# NORTH COAST RAIL TRAIL FINAL ENVIRONMENTAL IMPACT REPORT

## ADDENDUM

March 2020

This document is an addendum to the North Coast Rail Trail Final Environmental Impact Report (EIR) (SCH #2017092034, hereafter referred to as Final EIR).

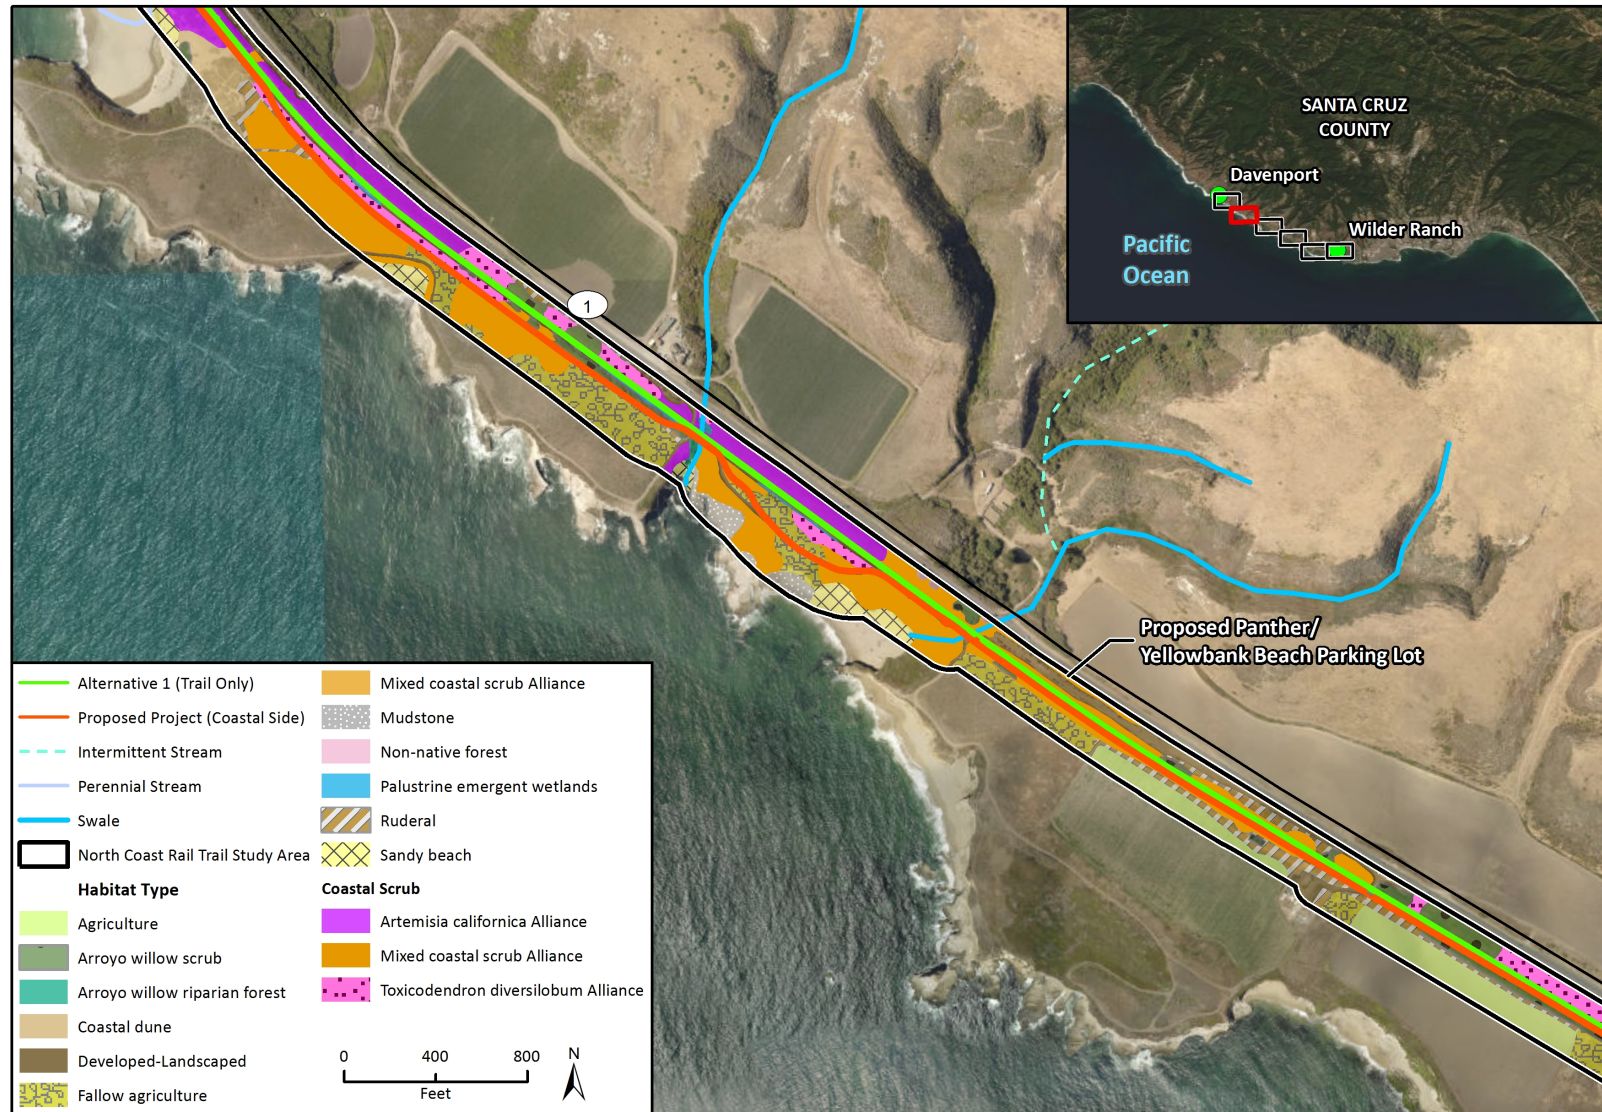
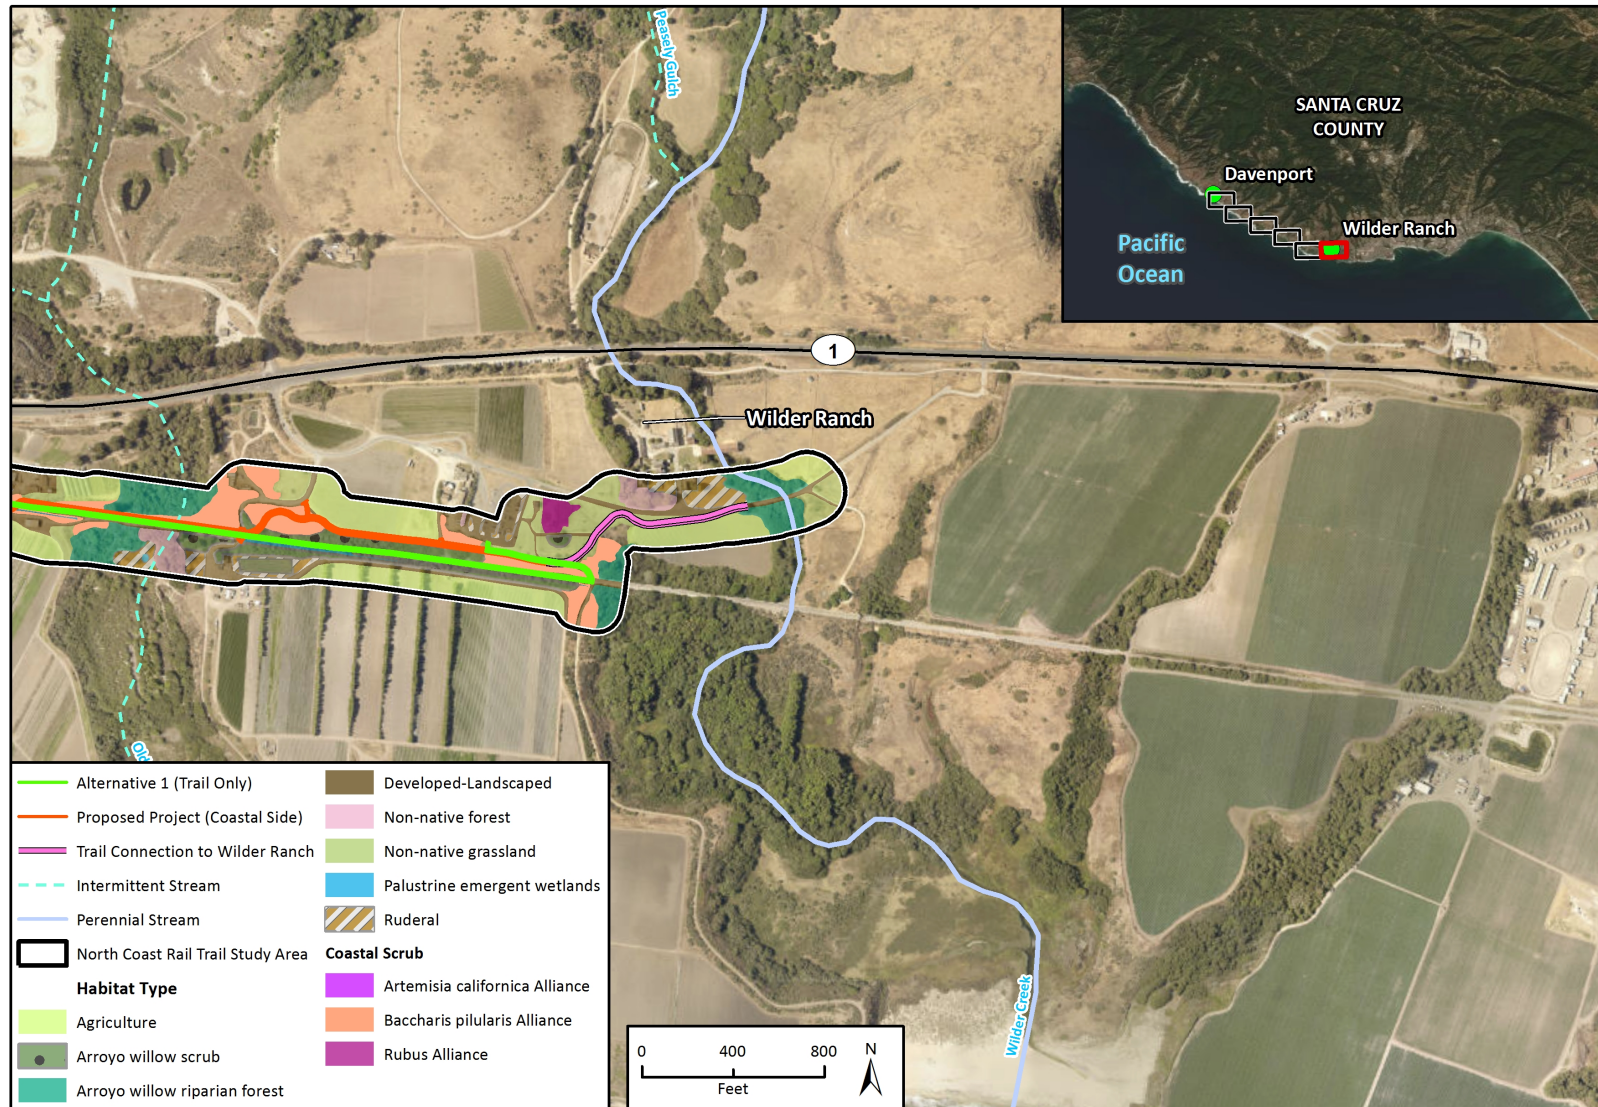
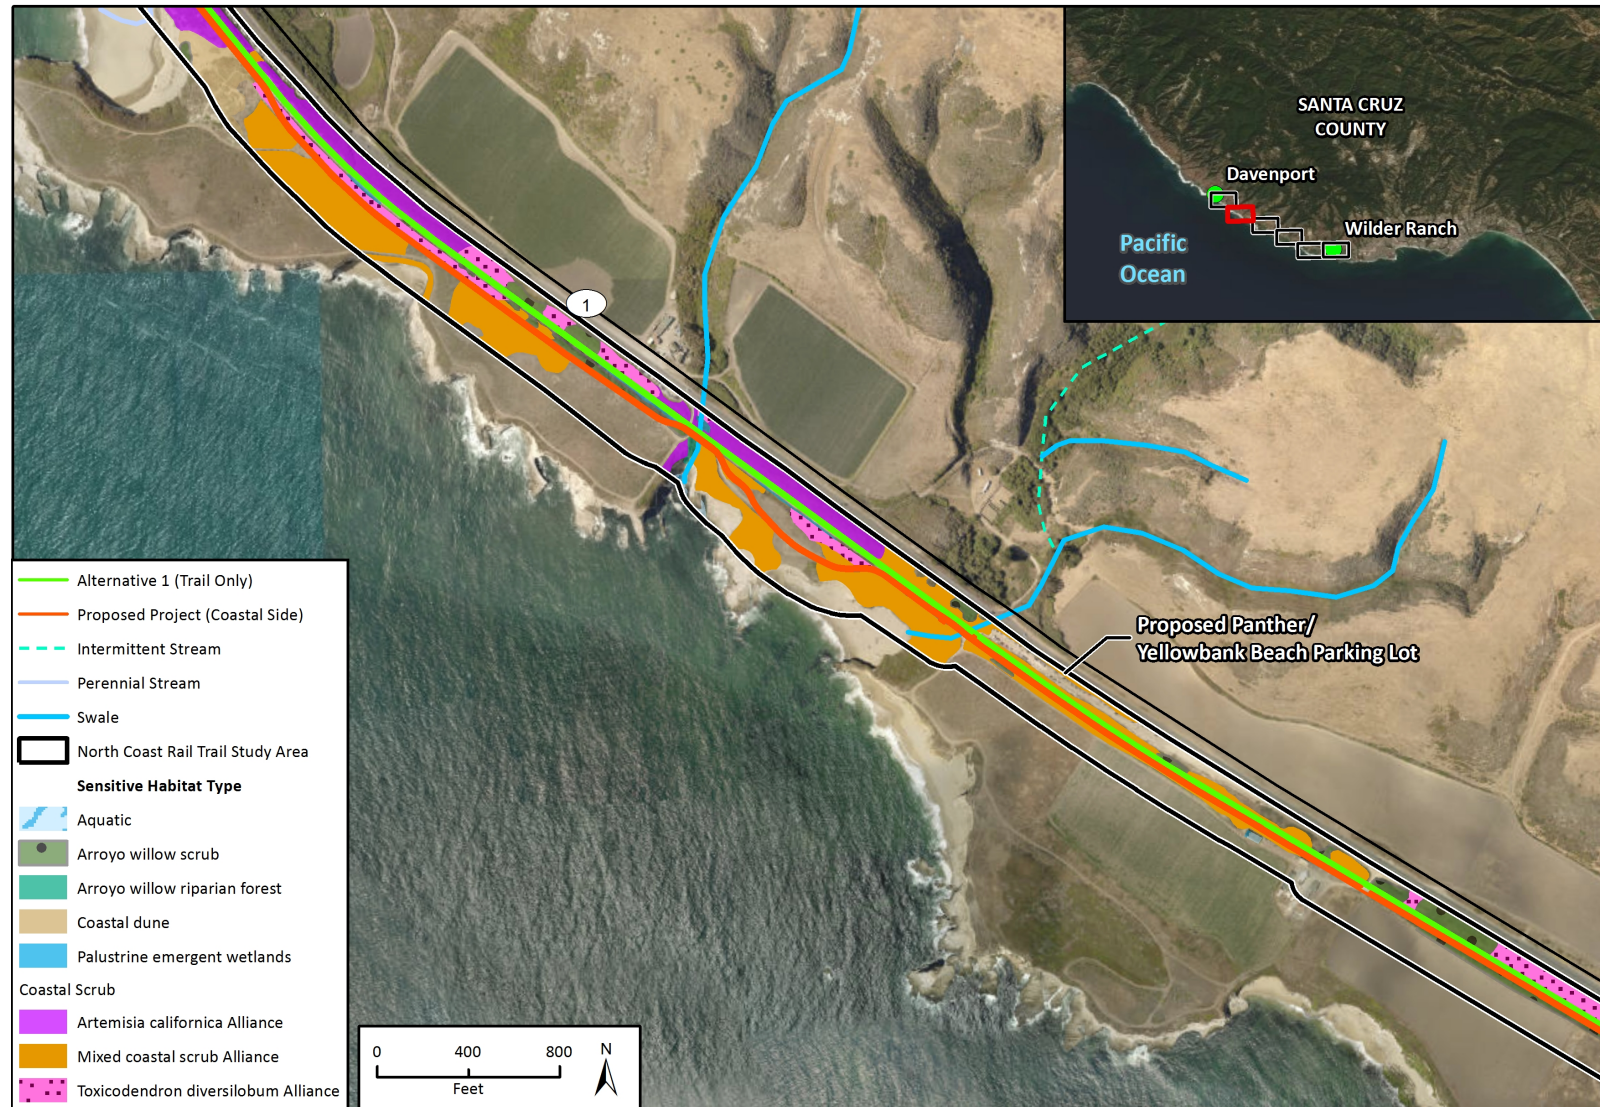
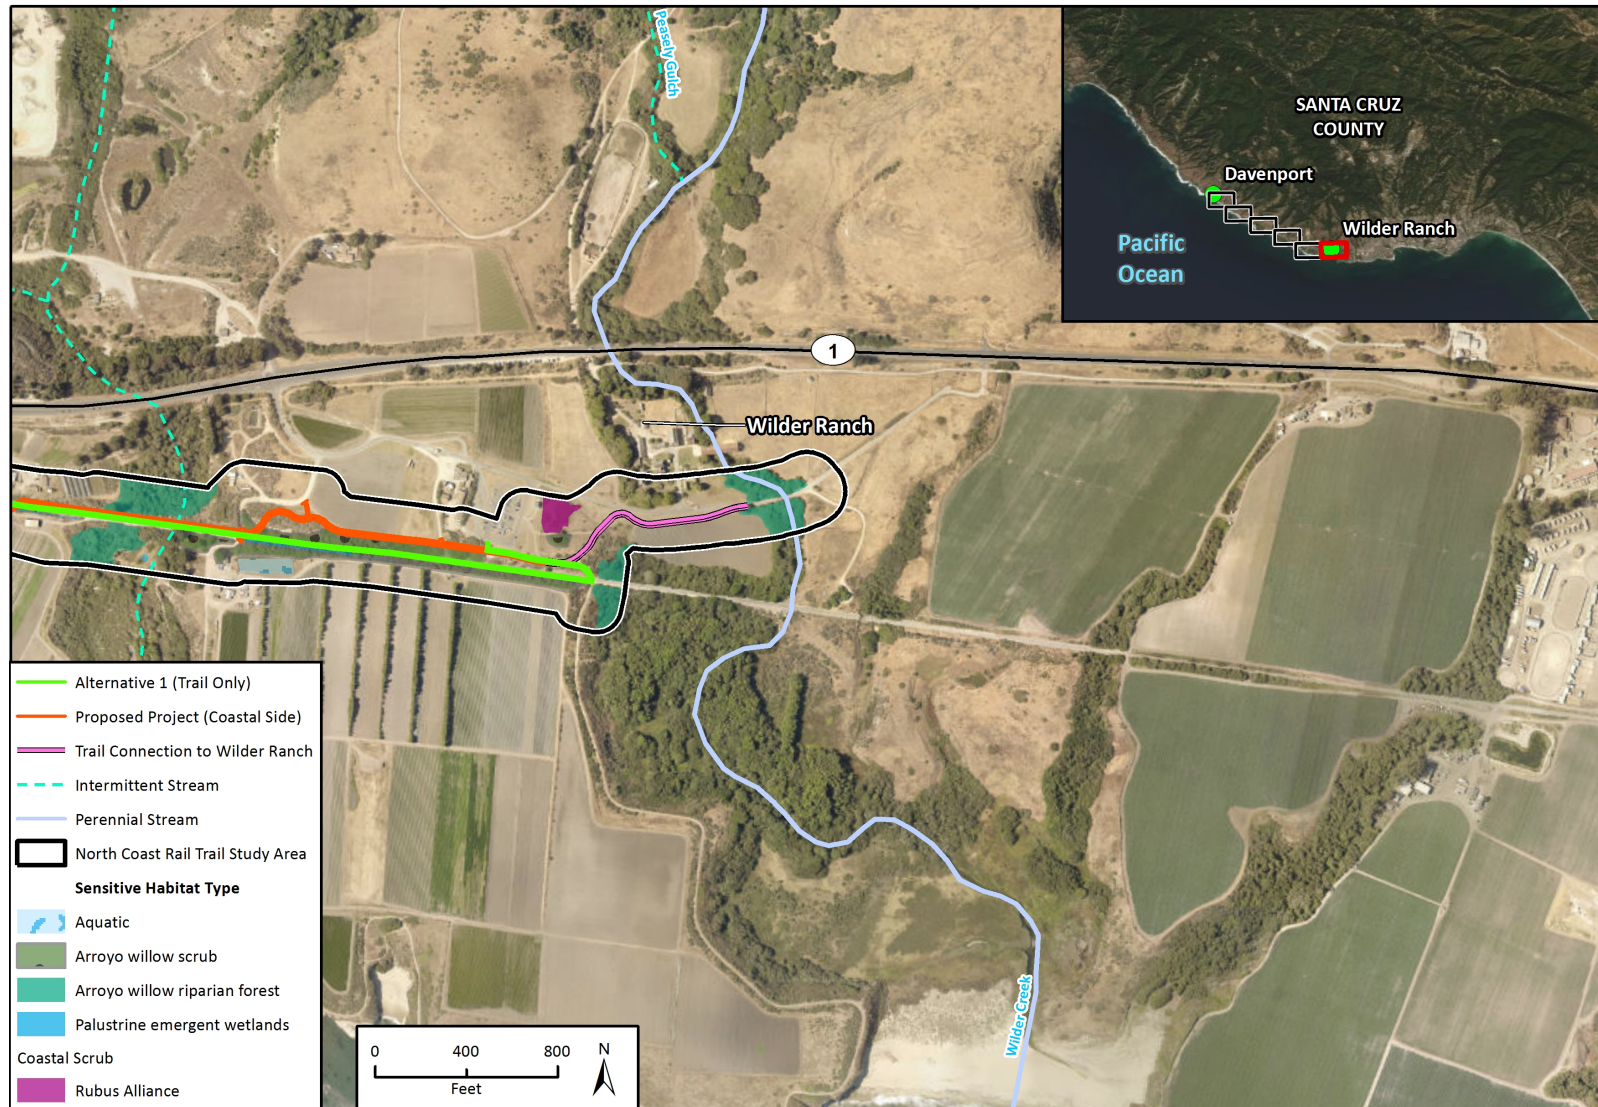
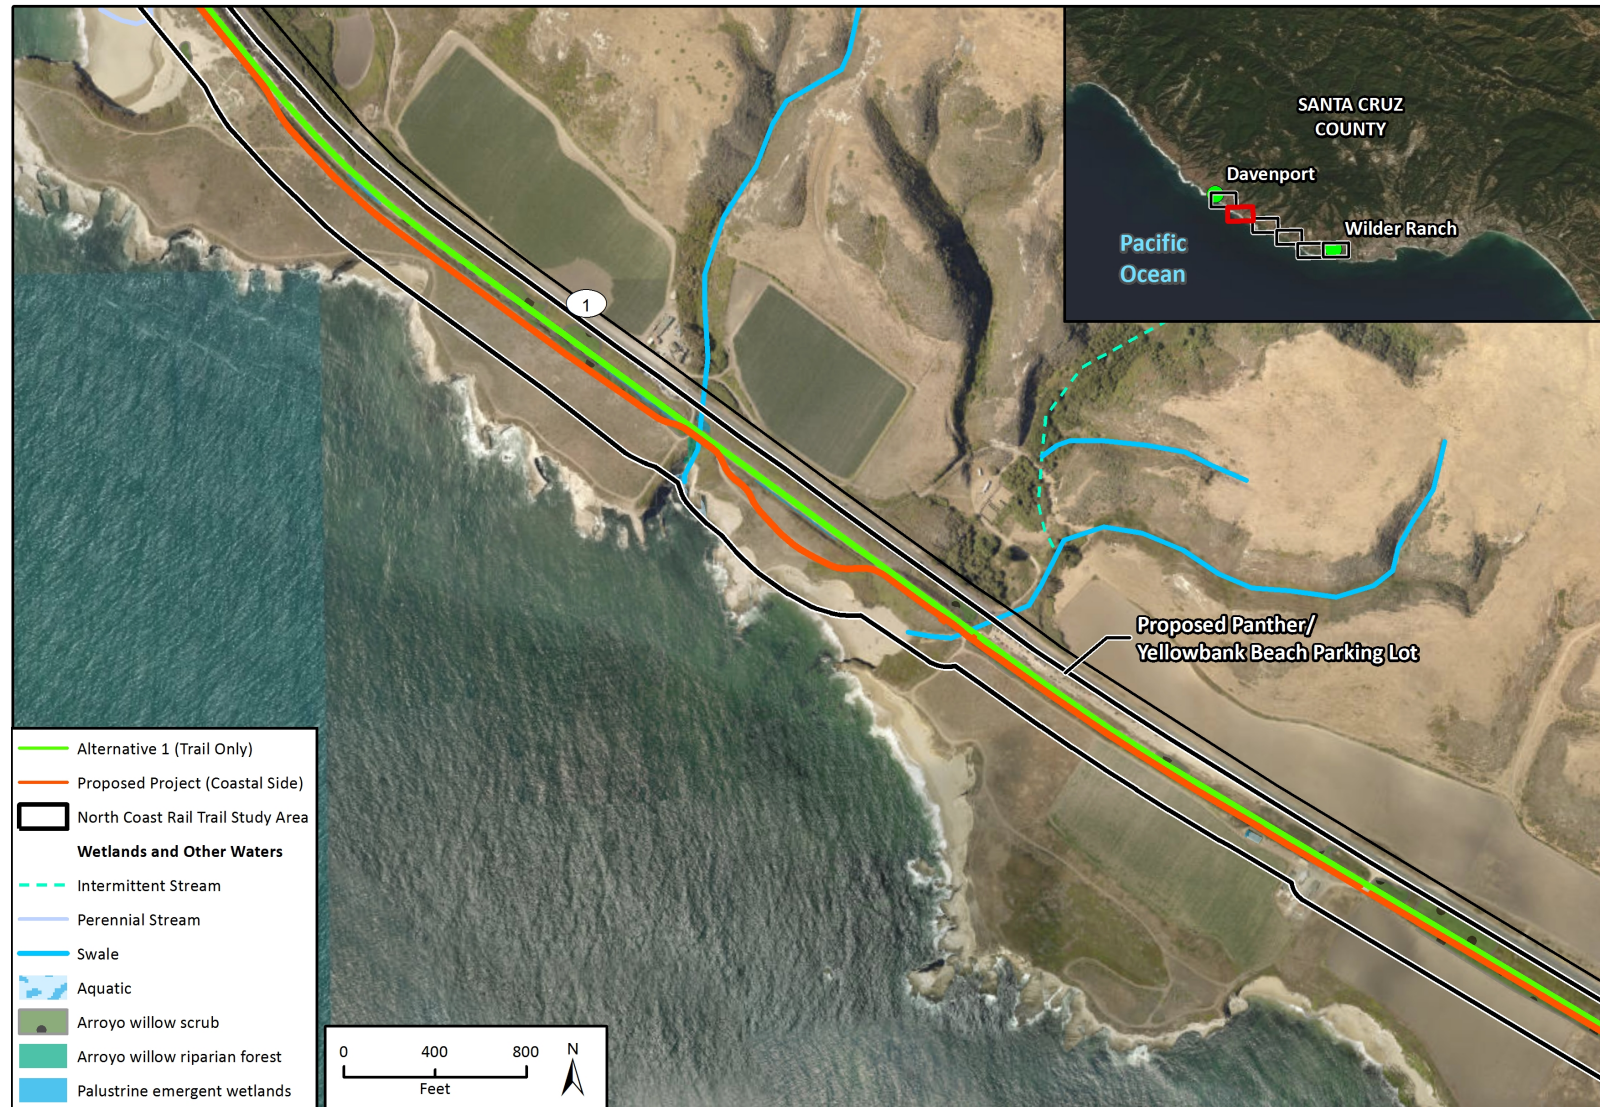
- n. Realign the portion of the trail extending through dune habitat near Bonny Doon parking lot, so it remains in the rail cut rather than above the rail cut on the coastal side (between Stations 86+00 and 90+00, as shown in Final EIR Appendix A.PP, Sheet 2 of 10, bottom). This would negate the requirement for Mitigation Measure BIO-8(b), Construct a Boardwalk in Coastal Dune Habitat. [Final EIR, Volume 2, Chapter 3.4 Biological Resources, Section 3.4.4, Project Impact Analysis, Impact BIO-8]

The trail realignment would keep the trail adjacent to the rail for an additional 175 feet, crossing through the existing sand dune that has begun to form on and adjacent to the railbed due to lack of maintenance, before beginning to climb up on to the bluff through ruderal and coastal scrub habitat located immediately southeast of Bonny Doon Beach (refer to Appendix A.PP, approximately station 90+00). An approximately 8-foot-high, 125-foot-long rockery retaining wall using native materials would be constructed on the coastal side of the trail (refer to Appendix A.PP, from approximately station 88+25 to 89+50). The retaining wall would be positioned below the bluff to eliminate the need to cut and lay back the sandy slope, thereby reducing the project footprint to accommodate the trail.

Changes to the trail alignment in Wilder Ranch would not impact sensitive habitats or special status species. The previous alignment was located on an existing paved road covering approximately 0.23 acres. The revised alignment is located on the coast side of this road and now affects 0.08 acres of developed, 0.06 acres of agriculture, and 0.09 acres of non-native grassland habitats within the footprint of the realigned Wilder Ranch trail segment. These habitats are not classified as sensitive and are highly degraded due to repeated and ongoing
